METROPOLITAN GOVERNMENT OF NASHVILLE AND DAVIDSON COUNTY

STAFF RECOMMENDATION
320 South 19th Street
March 20, 2013

Application: New construction—infill and accessory structure
District: Lockeland Springs-East End Neighborhood Conservation Zoning Overlay
Council District: 06
Map and Parcel Number: 08314028100
Applicant: John Root, RootArch
Project Lead: Melissa Baldock, melissa.baldock@nashville.gov

BOSCOBEL STREET

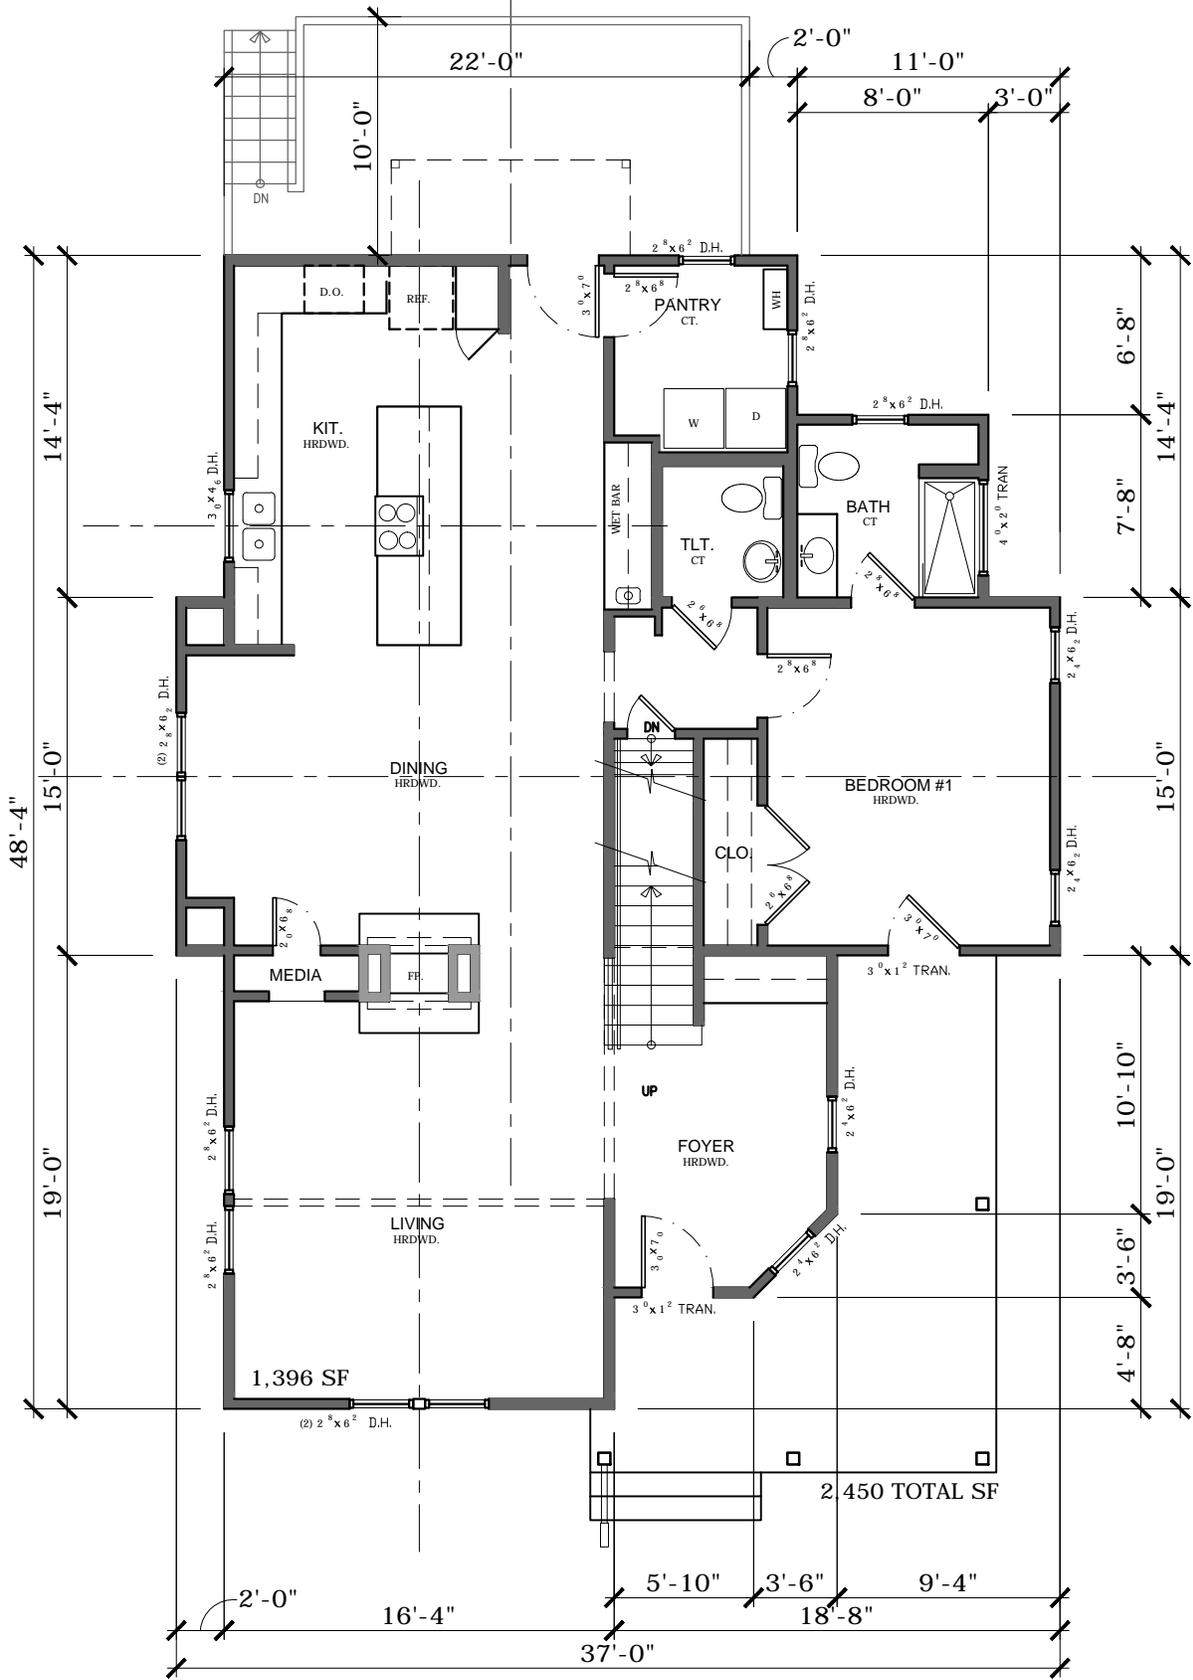
Outbuildings: A detached garage is proposed for the northwest portion of the lot. Because of the shallowness of the rear yard, the garage will not be located entirely behind the house, but will be placed to the left of the house, beyond its midpoint. The garage meets base zoning requirements for setbacks. It is three feet (3') from the rear/north property line and ten feet (10') from the left/west property line. Although in Lockeland Springs-East End garages are typically located behind the primary structures, staff finds the location of the proposed garage to be appropriate because it is pushed to the rear of the house and to its left/west as much as possible.

The site does not have access to the alley. The garage will be accessed via a new single-lane curb cut on Boscobel Street. The driveway fans out to have a double width at approximately forty feet (40') behind the sidewalk. The other properties in the immediate vicinity all have alley access, and therefore curb cuts and driveways are not typically found. However, curb cuts are found on other blocks within the Lockeland Springs-East End Neighborhood Conservation Zoning Overlay. Ideally, the curb cut would be on S 19th rather than at the front of the house on Boscobel but the shallow depth of the lot makes this scenario problematic. Because this site does not have access to an alley, staff finds a single-lane curb cut to be appropriate. Staff, however, recommends that two concrete strips be used rather than a solid driveway to at least the depth of where the house begins.

1. Staff review the asphalt shingle color, porch floor material, material of the rear deck and balcony, and the material and specifications for all windows and doors;
2. The mechanicals be located on the side beyond the midpoint of the house or at the rear;
3. The garage have two separate vehicular doors; and
4. The driveway be concrete strips until at least the front line of the house.

A3 FRONT GARAGE ELEVATION (SOUTH)
SCALE: 1/8"=1'-0"

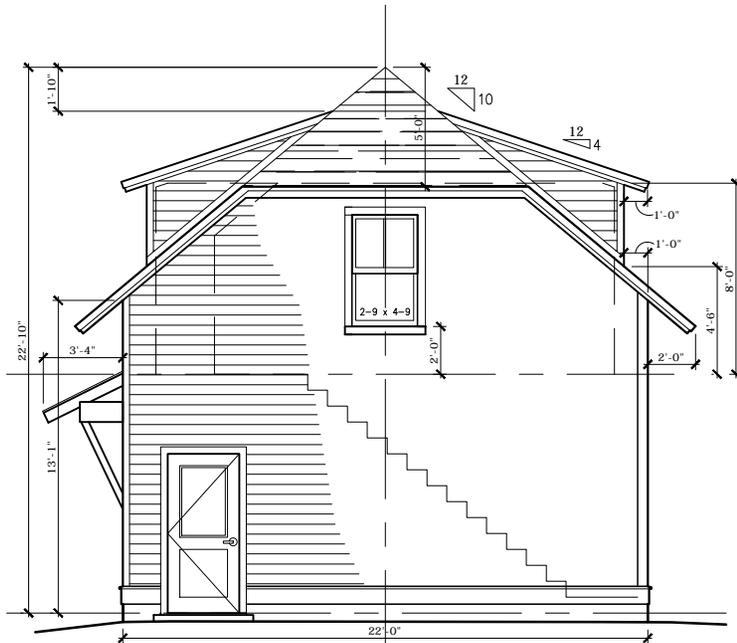
The garage doors will face Boscobel Street. In the past, the Commission has required that double garage doors facing the street should be two separate doors rather than one large door. Staff recommends two doors for the two-bay garage.
